Active Travel England Planning Response Detailed Response to an Application for Planning Permission

Application Ref: O/25/99506

Site Address: Navigator Quarter, Eastleigh, SO18 2NL

Description of development: Hybrid Planning Application - Outline application for development of the land adjacent to Southampton Airport to provide employment floorspace of up to 92,000 sqm (GIA) within Use Classes E(g) (ii & iii), B2 and B8 with ancillary offices and areas for service yards, car parking, landscaping, ancillary buildings and associated activities, and access from Wide Lane (all matters reserved except for access). Full planning application for initial infrastructure works and construction of new access road including site levelling and other engineering works. (EIA development)

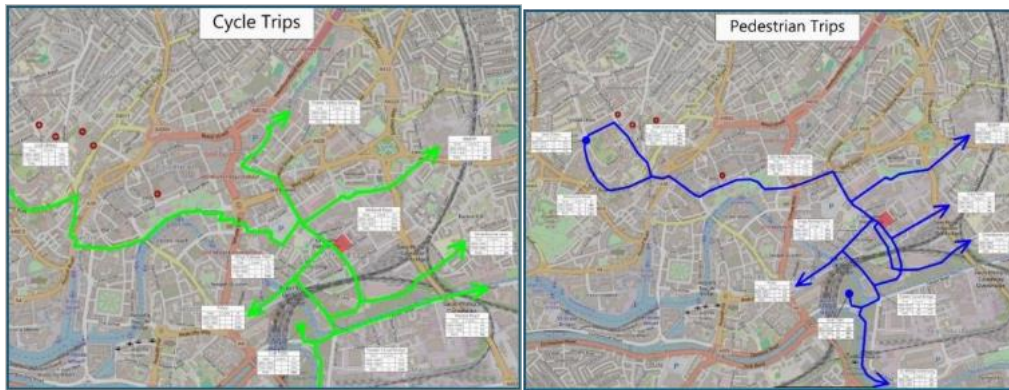
It is therefore welcomed that the applicant intends to provide a bus stop outside Unit 12 in the South Plot, subject to the Highway Authority's satisfaction. However, the Highway Authority's 8 August 2025 response identifies concerns:

- Uncertainty over whether service U1C will be diverted to the proposed bus stop.
- If diverted, it would only provide direct access from Southampton, not from the north.
- No direct pedestrian link between the southern and northern plots to conveniently access the stop.

These matters must be resolved to address accessibility gaps. Local bus stops should offer good natural surveillance, seating, lighting, shelter, real-time information, and raised boarding kerbs.
